Proposed Permit Modification Requests

Public Meeting
October 27, 2011
Santa Fe, New Mexico

Proposed Class 2 Permit Modification Requests (PMRs)

Update Ventilation Language

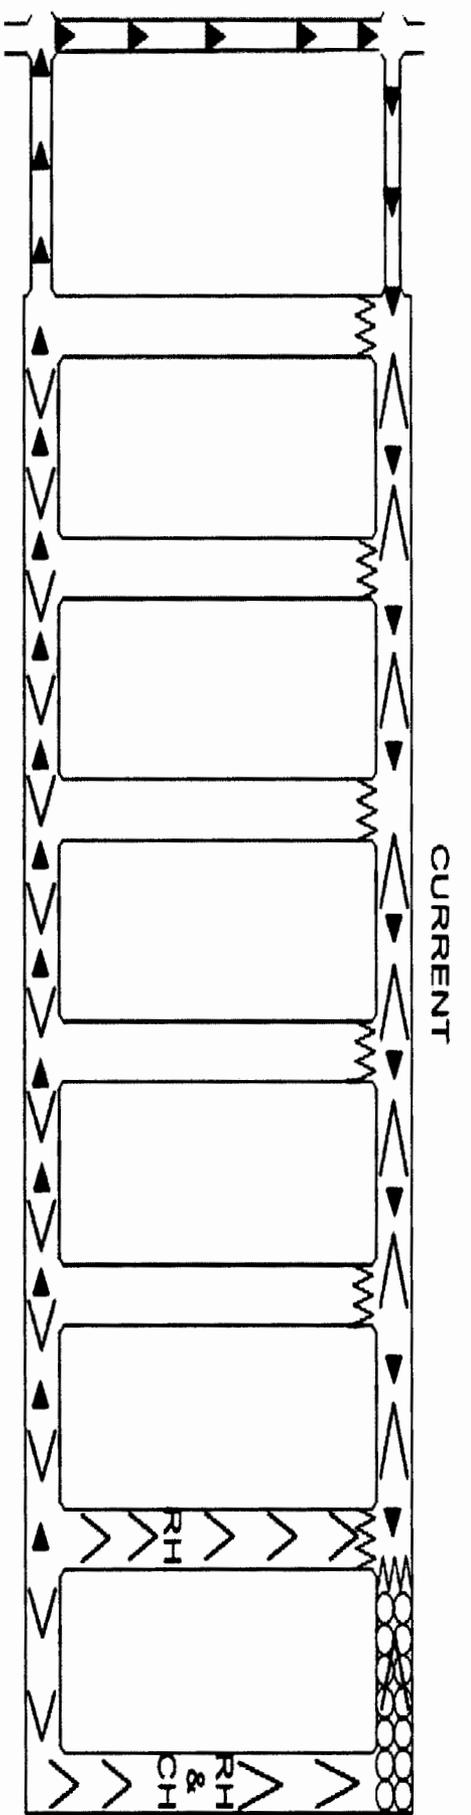
- The changes in this Permit Modification Request are the following:
 - Add a definition for a “filled room”
 - Add clarifying language to indicate that 35,000 scfm is required for worker entry into a room that is adjacent to a filled room thereby removing an inconsistency between Attachment A2 and Attachment O
 - 35,000 scfm must be maintained when workers enter Room 7 of any panel when CH TRU mixed waste is being disposed
 - Provide an exception to this requirement for restoring normal ventilation in a room adjacent to a filled room
 - Revise the 7 day notification to annual reporting

Update Ventilation Language

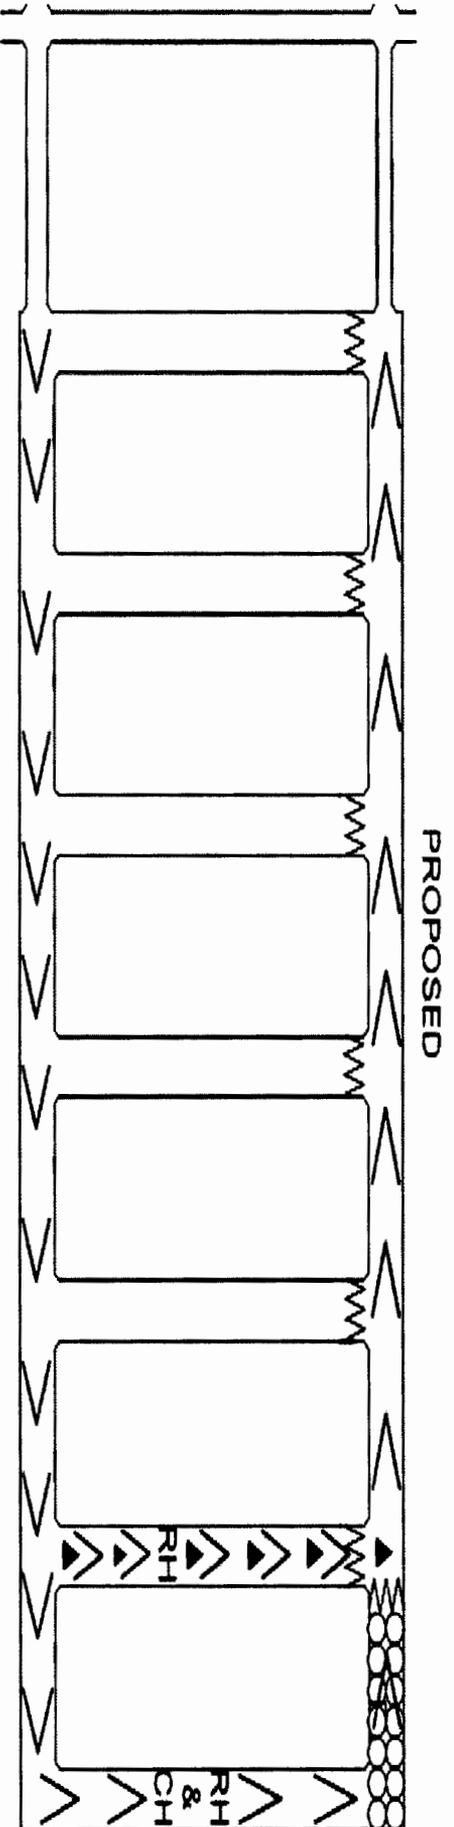
- Propose that workers are permitted to enter active rooms that are not adjacent to a filled room with ventilation $< 35,000$ scfm in order to perform activities such as geomechanical monitoring, adjusting ventilation regulators, perform ground control inspections, or RH equipment maintenance.

Addition of a Shielded Container

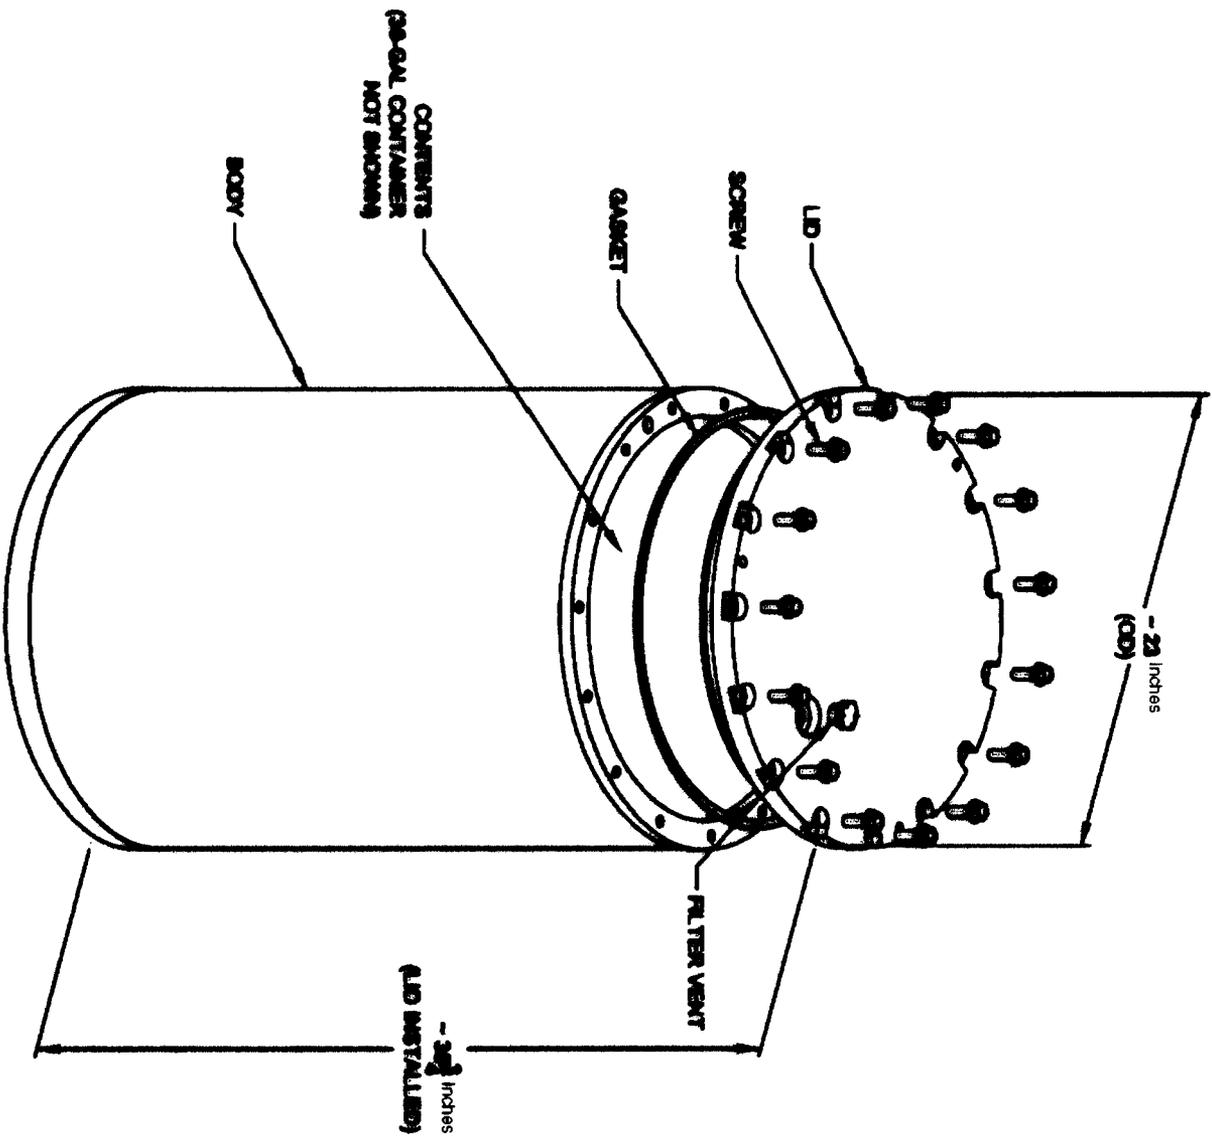
- The changes in this PMR are the following:
 - Addition of a new gamma shielded container for managing RH TRU mixed waste
 - This waste will be managed as CH TRU mixed waste, but will be counted towards the allowable RH TRU mixed waste repository limit

- Basis
 - This new container design allows RH TRU mixed waste to be managed as CH TRU mixed waste since the external surface dose rate is below 200 millirems per hour.
 - This change does not require the use of specialized emplacement equipment
 - The shielded container is an approved DOT 7A container and approved by the NRC for shipment in the HalfPACT.
